Category: Market Modelling

Submitted in Advance

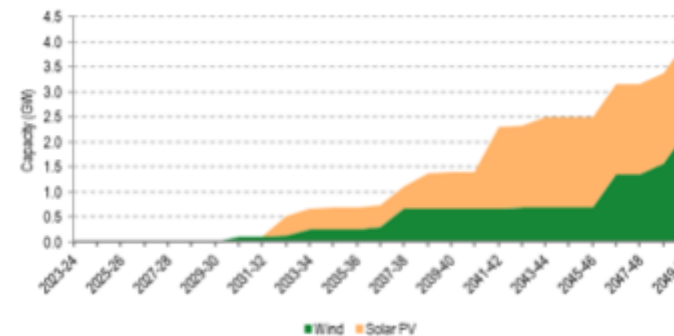
Why is only 700MW of the additional 1460MW + 200MW of renewables hosting capacity in the Western Victoria REZ used in the 15 years after WRL completion and only 350MW of the additional 900MW for South-West NSW REZ used in the 6 years after VNI West is completed?

The additional transmission capacity of VNI West allows more efficient use of renewables and enables additional wind and solar build. However, the quantity of wind and solar capacity built in each REZ are model outcomes. The model builds different technologies in the NEM on a least cost basis, considering the costs including capex, VOM, FOM and fuel costs if applicable. For renewables, the quality of resources and expected generation availability (on an hourly basis for multiple weather pattern reference years) as well as the available transmission capacity (and if required the cost of additional transmission capacity) are considered in the modelling.

The question is correct in the quoted numbers for the Western Victoria (V3) and South West NSW (N5) REZs (as shown in figures below) and the assertion that this means the increments in transmission capacity associated with VNI West Option 5 are not fully utilised during the quoted periods.

Even though REZ transmission increments are not fully utilised immediately after commissioning, Option 5 is assessed as having net benefits of approximately \$1.4 billion dollars. In this assessment of costs against benefits the relative timing of the two is a key influence on net position.
